UNITED STATES PATENT AND TRADEMARK OFFICE

APPLICATION NO.	FILING DATE	FIRST NAMED INVENTOR	ATTORNEY DOCKET NO.	CONFIRMATION NO.
10/662,536	09/15/2003	Jean Joseph Botti	DP-300006	2268

Office Action Summary

FIG. 1

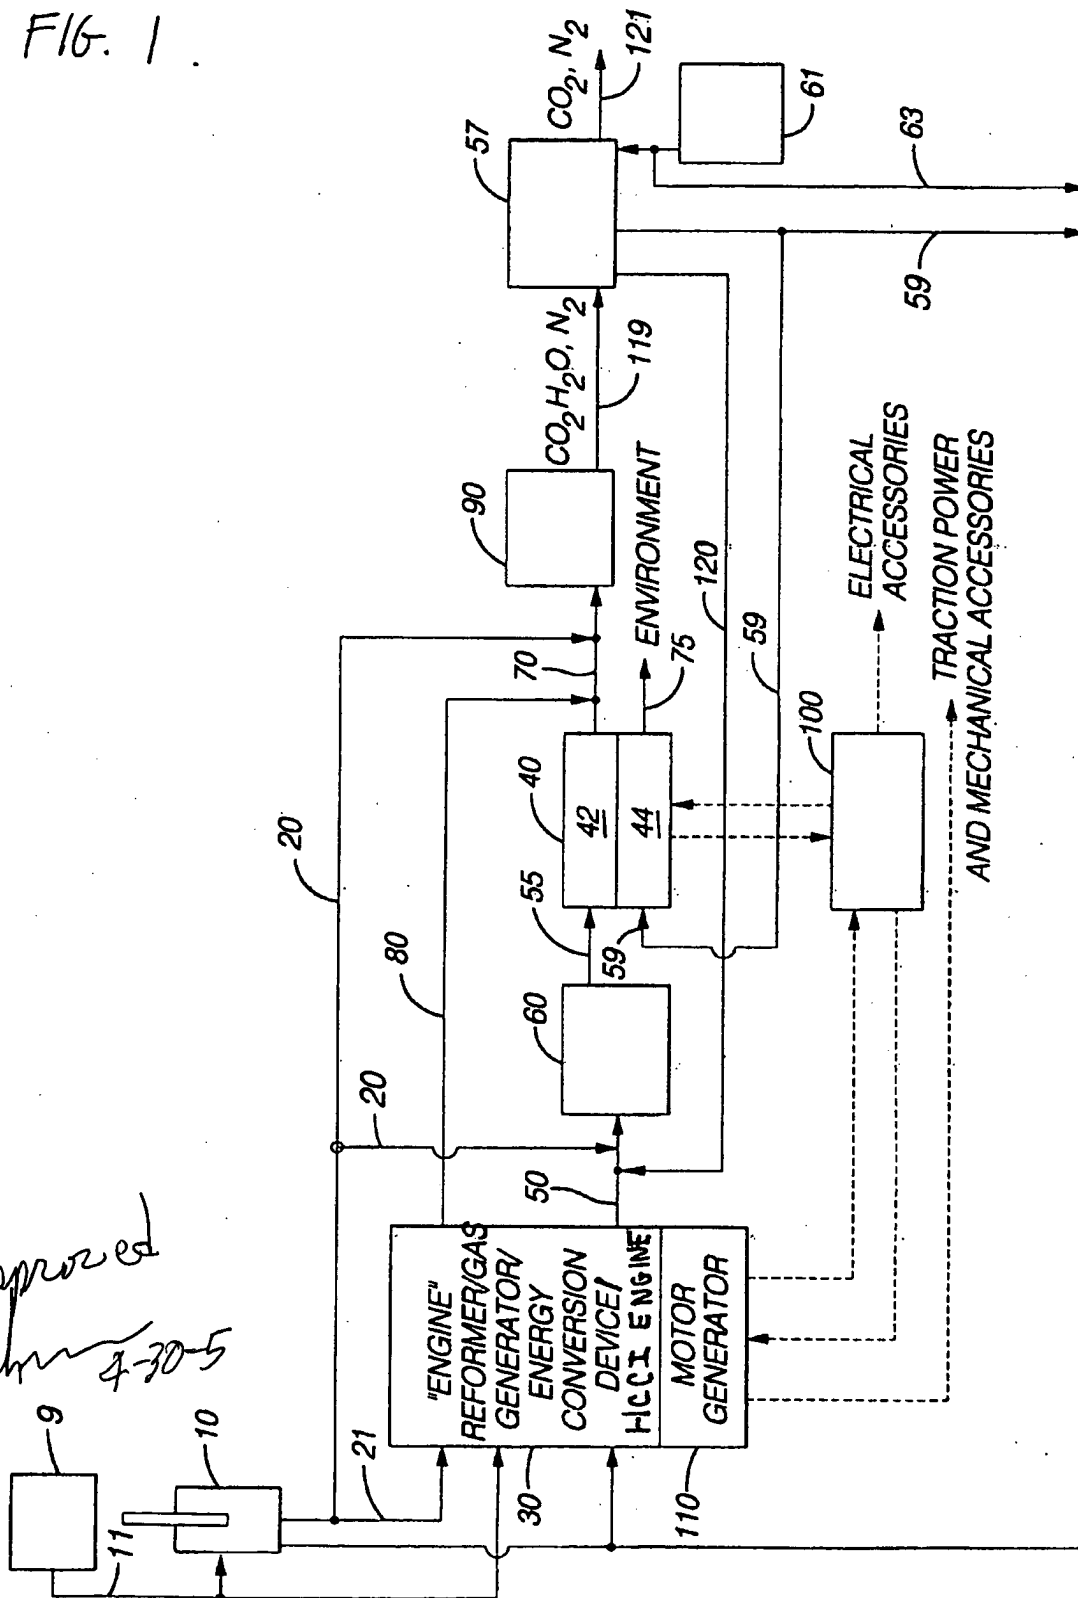
9. The drawings are objected to, as it is considered unclear how Figures 2-6 relate to Figure 1. Specifically, Figures 2-6 are best understood to be located within Figure 1, although it is not clear where on Figure 1 the structure of Figures 2-6 is located. As noted above, in some instances, the structure shown on Figures 2-6 is believed to replace engine 30, while in other instances, the structure shown on Figures 2-6 is believed to be used in "conjunction" with engine 30.

Also, regarding Figure 4, although Figure 4 shares common structure (57) with Figure 1, Figure 4 is described on page 11 as providing a "hydrogen rich exhaust" from reference number 410 on Figure 4. As best understood, this "hydrogen rich exhaust" would then be fed into the inlet of the fuel cell. However, Figure 4 shows that reference number 410 is directly upstream of reference number 57, which is also shown on Figure 1. However, comparison of Figures 1 and 4 show that reference number 57 is "downstream" of the fuel cell 40, which would mean that reference number 410 would

also be "downstream" of the fuel cell, since Figure 4 shows no other components between reference numbers 57 and 410. This leaves unclear the purpose of producing a hydrogen rich gas stream downstream of a fuel cell that is then fed only through a heat exchanger (57).

11. The drawing correction dated 3-10-2005 in which the words "/HCCI ENGINE" was added to "block 30" is not approved, as this implies block 30 as it now "reads" on Figure 1 is either an "engine reformer", "gas generator", "energy conversion device" or an "HCCI engine". As best understood from lines 1-3 of page 10, reference number 30 can be configured as any of the embodiments of Figures 2-4 and that the HCCI is an "electrical ignition" associated with Figure 2. This also leaves unclear why the abbreviation "HCCI", as noted above is best understood to be an "electrical ignition" is associated with the word "engine" as noted above.

From this, it would seem to be most clear if block 30 of Figure 1 "listed" the embodiments of Figures 2-4, and also including the "engine" of Figure 1, and that the

HCCI were shown on Figure 2. Again note, as mentioned above, that there seems to be some confusion where Figure 4 is actually located in Figure 1. Also, adding the HCCI in Figure 2 at a specific location may result in a new matter objection, unless support can be found for this HCCI location in the original disclosure. Regarding Figures 5 and 6, these Figures are best understood to be "oxygen enrichment devices" that may optionally be used with the embodiments of Figures 2-4, particularly Figure 3. Applicant may want to consider showing these devices "upstream" of reference number 30 in Figure 1 for clarity.

26. The drawing objections made on the last Office Action have been repeated on this Office Action, as for most part, the Applicant did not address the drawing objections in the amendment dated 03-10-2005. The drawing amendment dated 03-10-2005 to amend Figure 1 to overcome one drawing objection made on the last Office action was not approved for reasons set forth on this Office Action.

Proposed Drawing
Correction to
FIG. 1.

not approved
By *[Signature]* 4-30-05
